Comfit Composite Knit Ltd (Extensions 2)

Gorai, Mirzapur, Tangail
(24.163342, 90.419976)
8 May 2023 & 30 May 2023

Building Information

Available concrete cylinder test report (3 sets) for slab

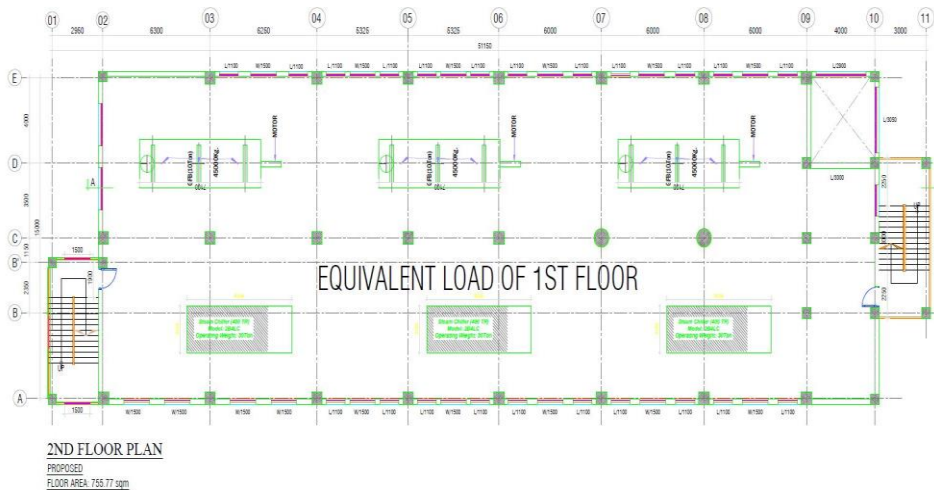
3 sets of concrete cylinder test reports were available for slab which doesn't comply with the frequency as per BNBC. Building engineer is required to ensure the in situ concrete strength by taking concrete core.

Dampness on roof slab

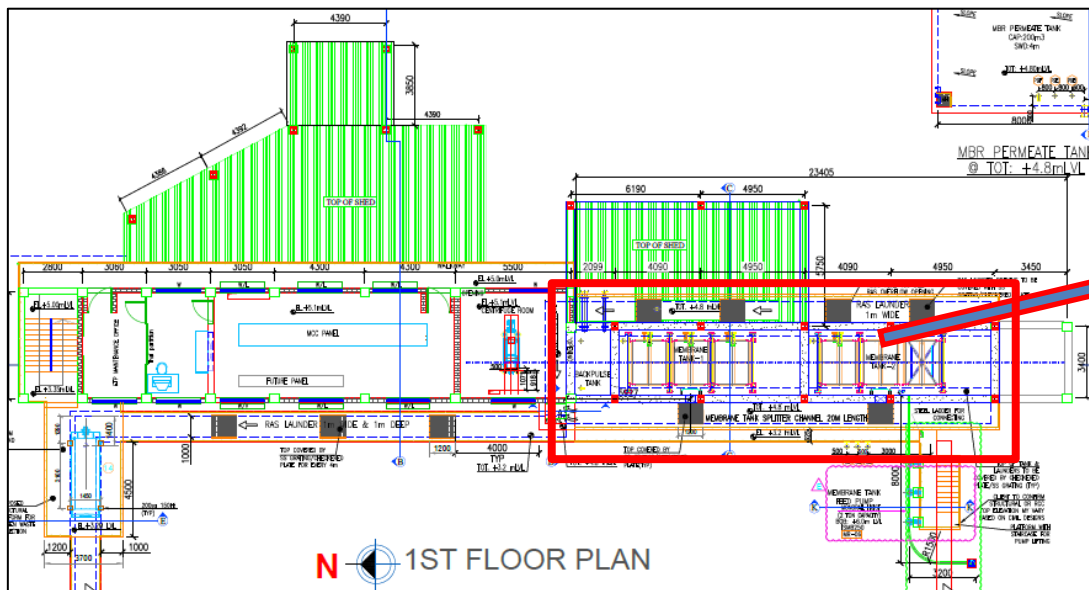
Dampness and vegetation were observed on roof slab. Factory is required to improve drainage system on roof slab.
